Your reference APP/23/00246

Land adjacent 38 - 45 Robin Gardens, Waterlooville

4No. three bedroom terraced dwellings with associated parking and landscaping

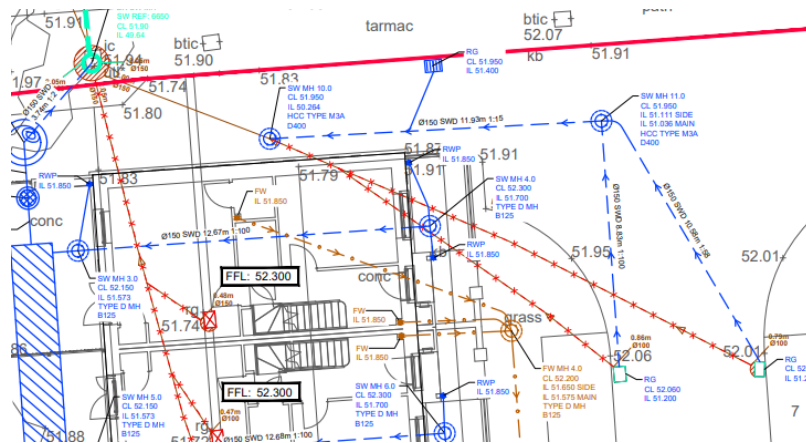
Where possible, adoptable drainage should not have a bend in the line, and this should be revised as shown below.
